06-324r3 SAS-2 Modifications to the SAS Speed Negotiation

To: T10 Technical Committee
From: Amr Wassal, PMC-Sierra (amr_wassal@pmc-sierra.com)
Stephen Finch, STMicroelectronics (steve.finch@st.com)
Date: 20 September 2006
Subject: 06-324r3 SAS-2 Modifications to the SAS Speed Negotiation

Figure 122 — SAS SNW-1, SNW-2 and Final-SNW

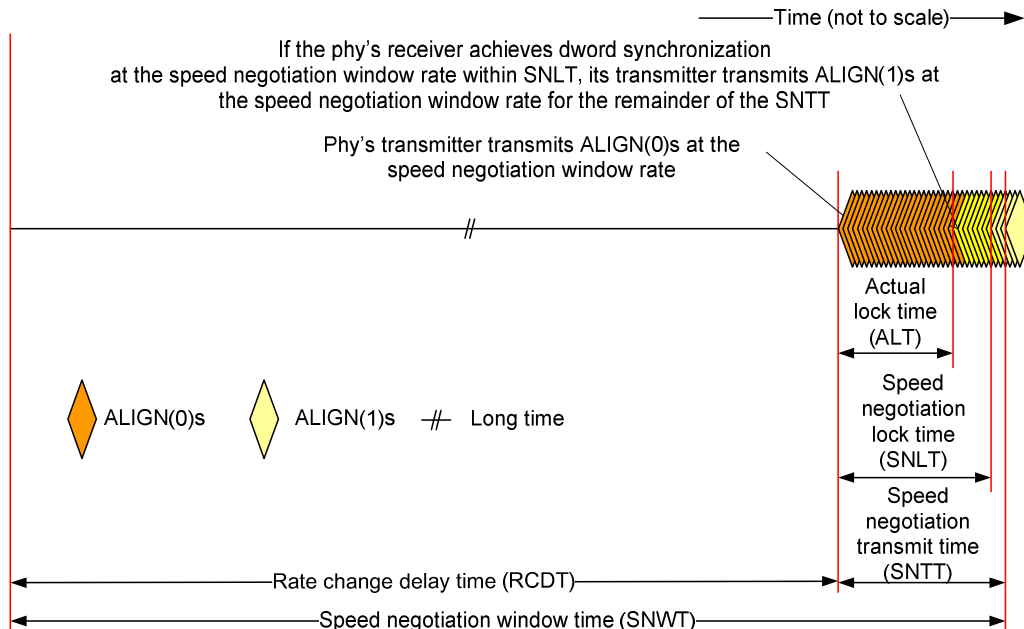
Figure 122 defines the SAS speed negotiation window format for SNW-1, SNW-2 and Final-SNW, including:

The speed negotiation window shall consist of the following transmission sequence:

- 1) transmission of D.C. idle for an RCDT; and
- 2) if the phy supports the physical link rate or if this is the Final-SNW, transmission of ALIGNs at the physical link rate specified below, for the remainder of the entire speed negotiation window time. If the phy does not support the physical link rate, transmission of D.C. idle for the remainder of the entire speed negotiation window time.

The physical link rate for Final-SNW shall be:

- a) 1,5 Gbps if SNW-1 was valid and SNW-2 was invalid, or
- b) 3,0 Gbps if SNW-2 was valid and SNW-3 was invalid

Figure 123 — SAS SNW-3

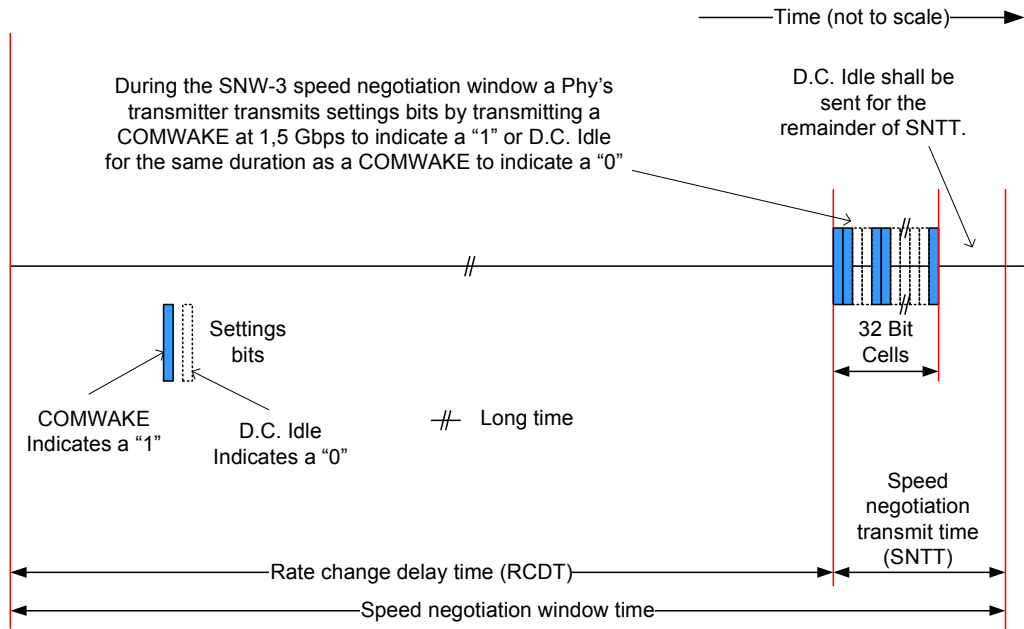
During SNW-3 each phy transmits 32 bits of information that describes its capabilities and receives 32 bits of information that describes the capabilities of the far end phy.

Each of the 32 bits of information can be a "1" or a "0". The transmitter transmits 32 bit cells at the beginning of the SNTT portion and then transmits D.C. Idle for the remainder of SNTT.

Each bit cell consists of the transmission of a COMWAKE (see 6.6.2) or the transmission of D.C. Idle for a period of time equivalent to the length of a COMWAKE. The transmission of a COMWAKE indicates a value of "1". The transmission of D.C Idle for a period equivalent in length to a COMWAKE indicates a value of "0".

COMWAKE shall be transmitted at 1,5 Gbps.

Figure 123 defines the SAS SNW-3, including:

Figure 124 — SAS Train-SNW

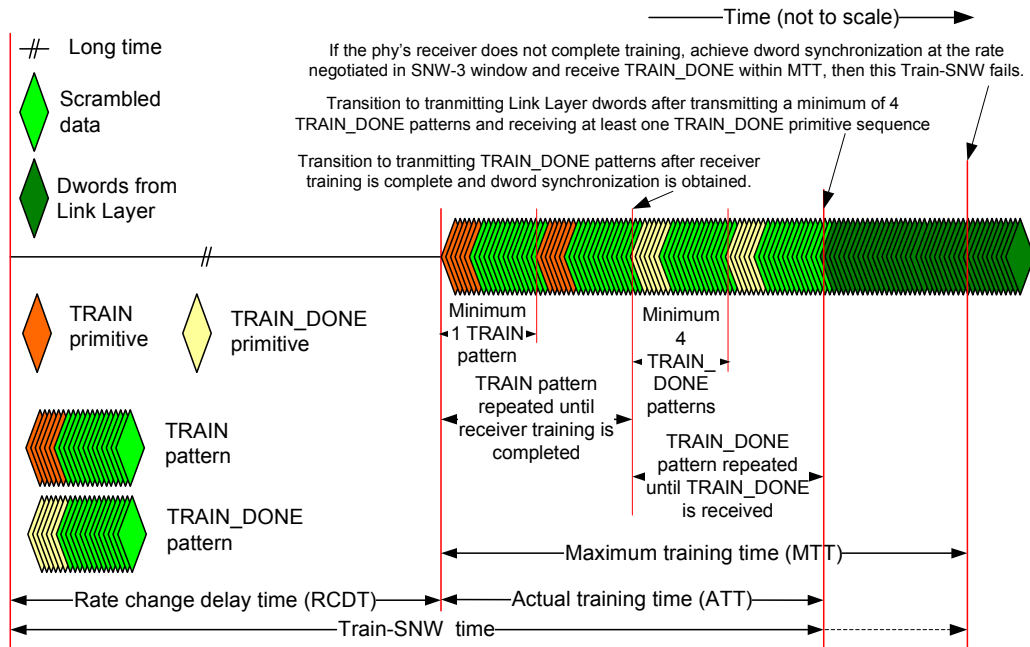
Figure 124 defines the Training-SNW, including:

The Train-SNW utilizes TRAIN and TRAIN_DONE primitive sequences as defined in x.x.x.x. These primitive sequences are used within training patterns.

There are two training patterns, the TRAIN pattern and the TRAIN_DONE pattern. Each training pattern consists of:

- 1) either a TRAIN primitive sequence if the pattern is a TRAIN pattern, or a TRAIN_DONE primitive sequence if the pattern is a TRAIN_DONE pattern; and
- 2) 58 dwords of value 0000_0000h that are transmitted scrambled and 8b10b encoded.

The transmitter shall start transmitting TRAIN patterns at the beginning of the MTT portion of the Train-SNW window. The number of TRAIN patterns transmitted is determined by the time required for the phy's receiver to complete training.

When the phy's receiver is trained and has acquired dword synchronization, the phy shall stop transmitting the TRAIN patterns and start transmitting with TRAIN_DONE patterns. A minimum of four TRAIN_DONE patterns shall be transmitted.

If the phy has transmitted four or more TRAIN_DONE patterns and has received a minimum of one TRAIN_DONE primitive sequence before the maximum training time (MTT) has been reached, the phy shall stop transmitting TRAIN_DONE patterns and shall start transmitting dwords from the link layer. In this case the Train-SNW was successful.

Figure 125 — SAS speed negotiation sequence (phy A: G1, G2, G3, phy B: G2 only)

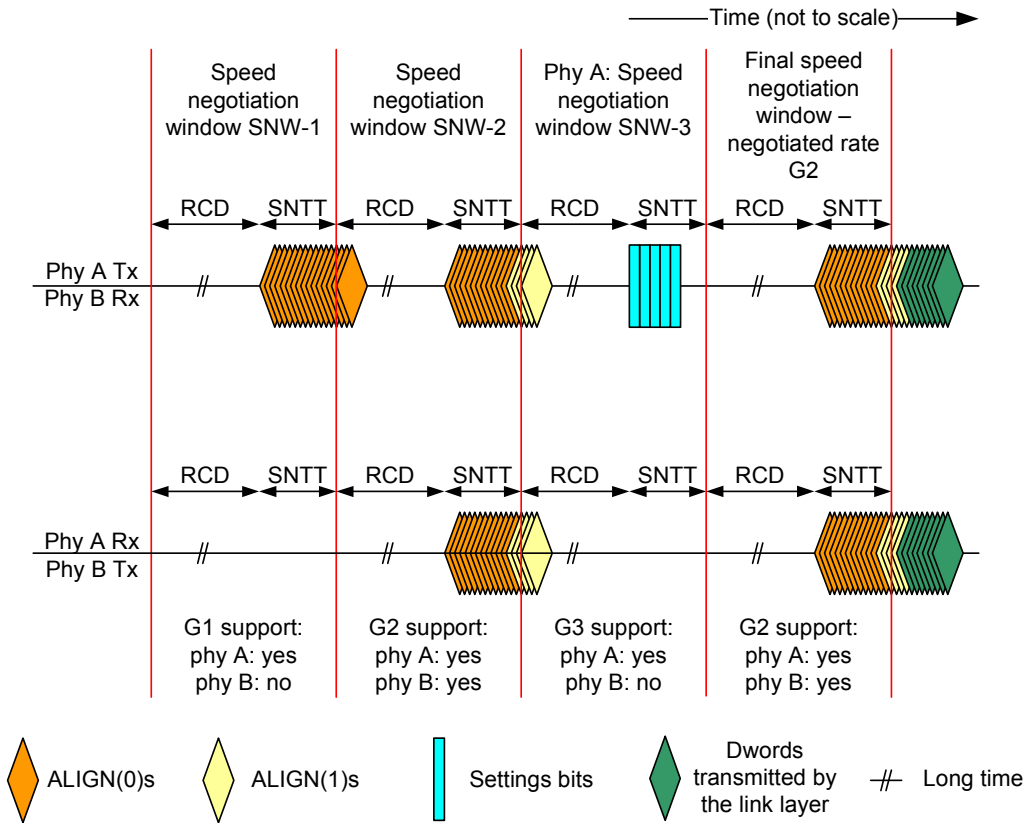
Figure 125 shows speed negotiation between a phy A that supports G1 through G3 and a phy B that only supports G2. Both phys run:

- 1) the SNW-1, supported by phy A but not by phy B;
- 2) the SNW-2, supported by both phys; and
- 3) the SNW-3, supported by phy A but not by phy B.
- 4) the Final-SNW at 3,0 Gbps

Phy A determines the correct speed negotiation sequence by detecting a valid SNW-2 window followed by an invalid SNW-3 window and correctly proceeds to a Final-SNW window at 3,0 Gbps.

Figure 126 — SAS Final-SNW phy reset problem

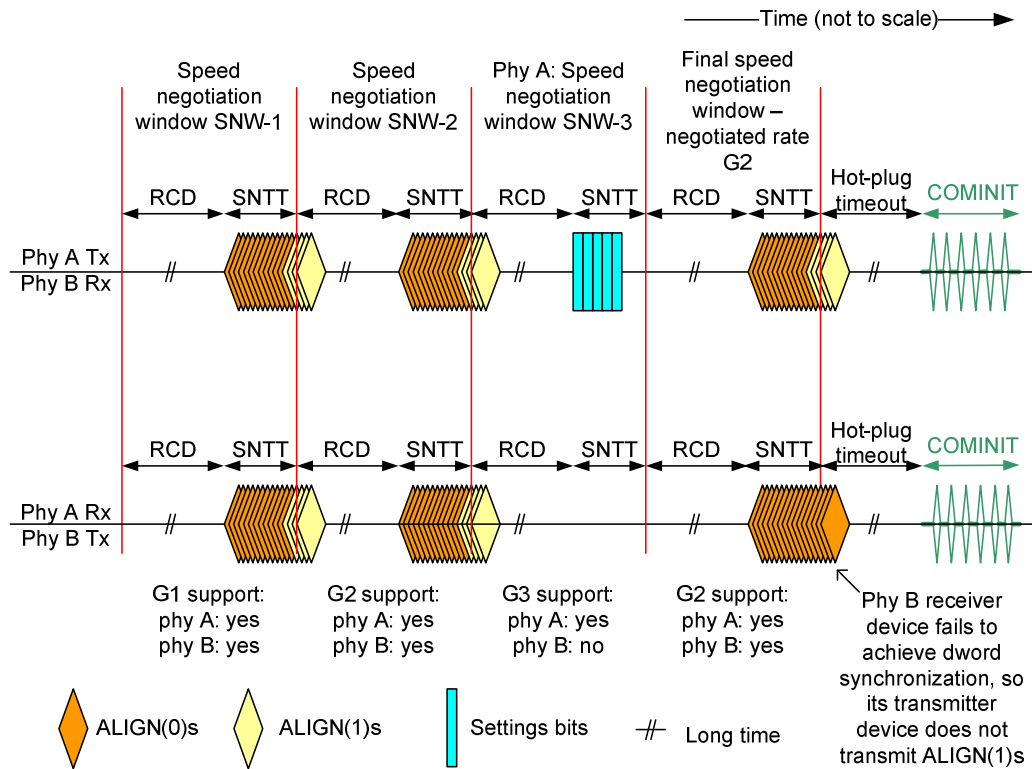
Figure 126 shows a speed negotiation sequence where phy B does not achieve dword synchronization during the Final-SNW. If this occurs, the handshake is not complete and the phy reset sequence is retried.

Figure 127 — SAS speed negotiation sequence (phy A: G1, G2, G3 or higher, phy B: G1, G2, G3 or higher)

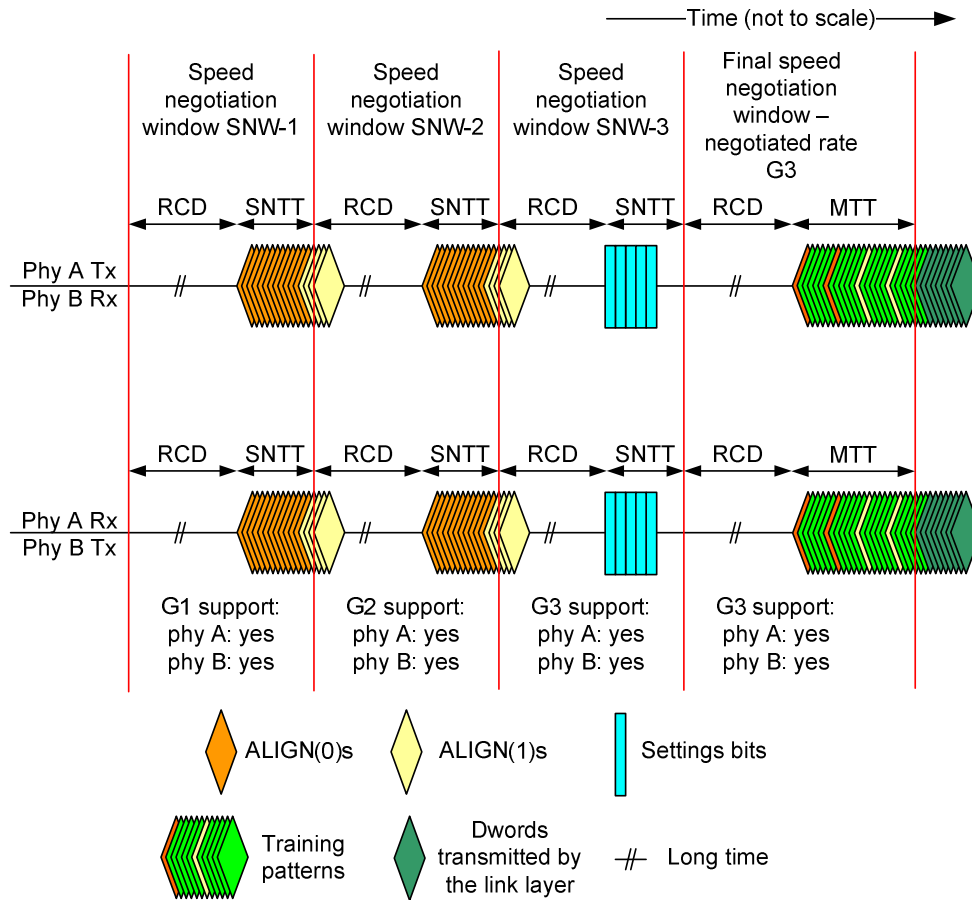
Figure 127 show speed negotiation between a phy A and a phy B that both support G1 and G2 rates without requiring training and also support additional capabilities. Both phys run:

- 1) the SNW-1, supported by both phys;
- 2) the SNW-2, supported by both phys; and
- 3) the SNW-3, supported by both phys where the settings bits are exchanged and the highest common rate supported by both phys is negotiated; and
- 4) the Training-SNW, supported by both phys where training is done.

Figure 128 — SAS speed negotiation sequence - SNW-3 (maximum SNW) phy reset problem

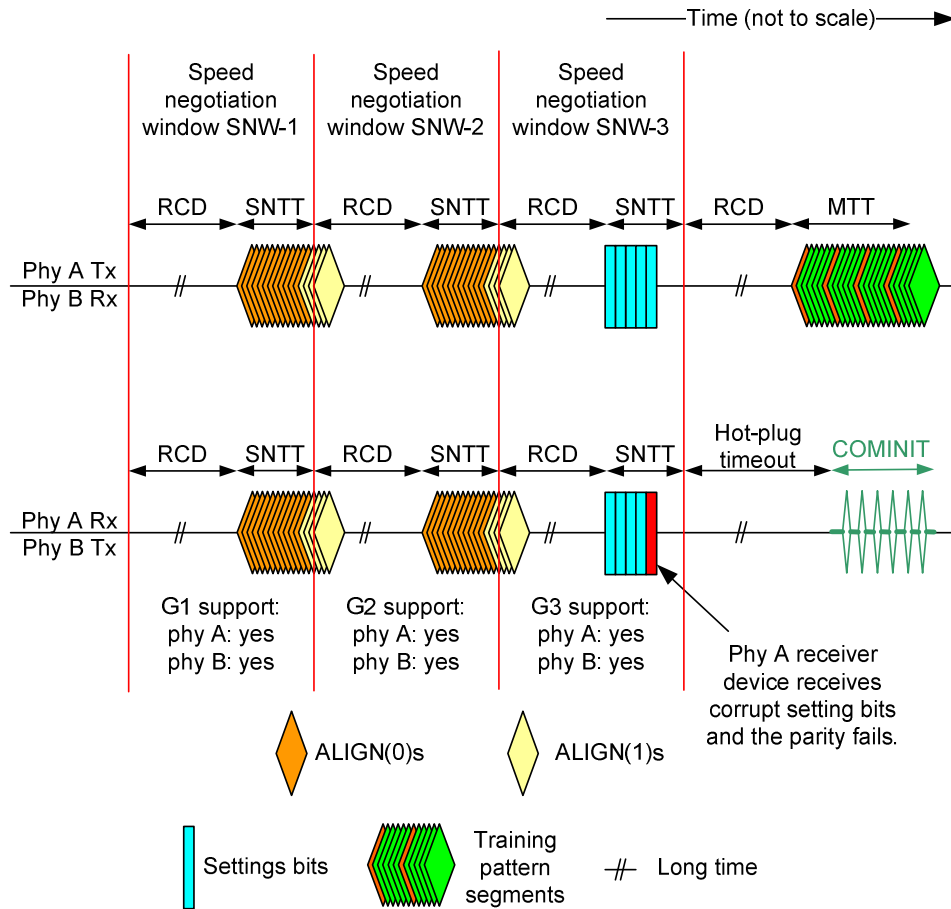
- 1) the phys do not exchange the settings bits properly (e.g., due to a parity error) in SNW-3 window (see Figure 128); or
- 2) either phy does not complete training within the MTT interval of several training windows exhausting all common settings exchanged in SNW-3 (see Figure 129)..

Figure 131— SP (phy layer) state machine - SAS speed negotiation states

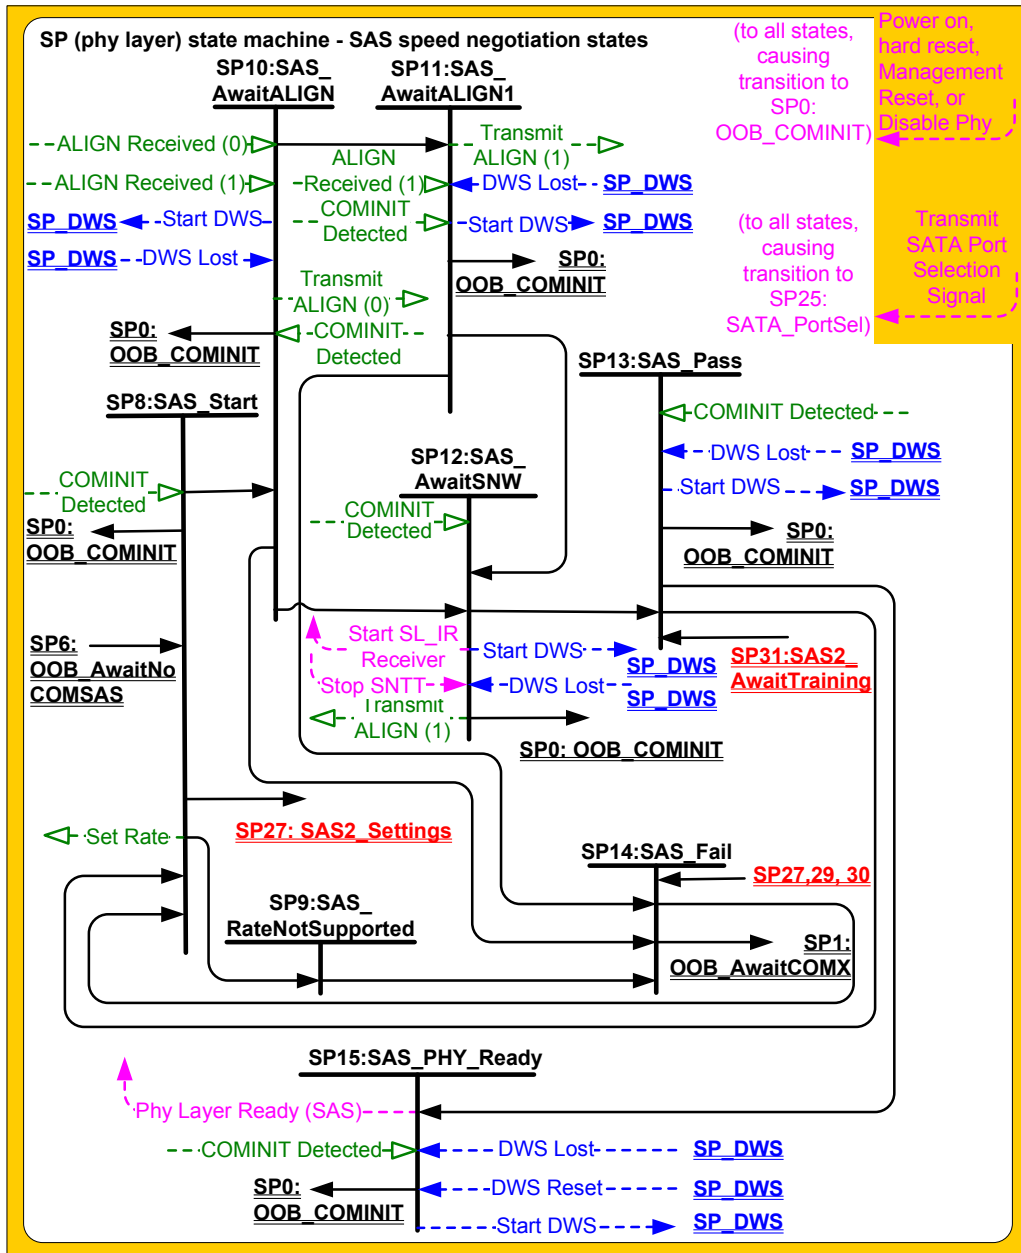
Figure 131 shows the SAS speed negotiation states, in which the phy has detected that it is attached to a SAS phy or expander phy rather than a SATA phy, and performs the SAS speed negotiation sequence. These states are indicated by state names with a prefix of SAS.

Figure 132 — SP (phy layer) state machine - SAS speed negotiation states (continued)

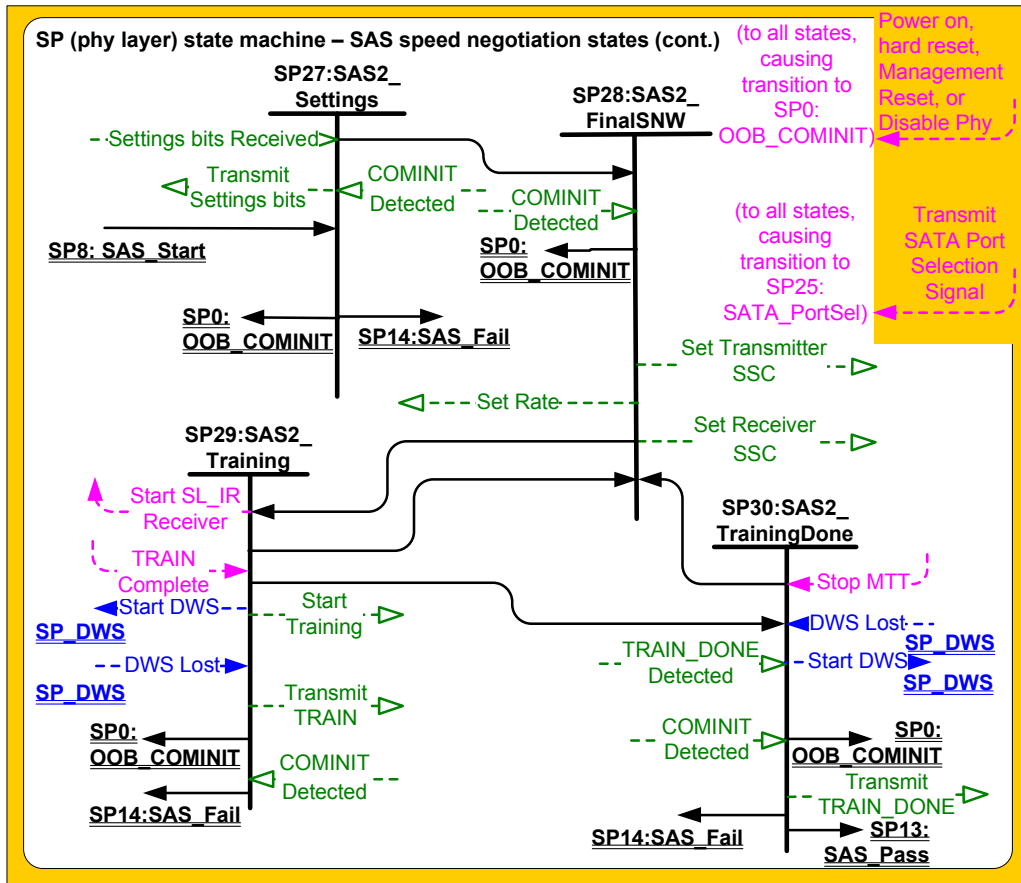
Figure 132 shows the rest of the SAS speed negotiation states related to SNW-3 and the SNW-Final speed negotiation windows. These states are indicated by state names with a prefix of SAS2.
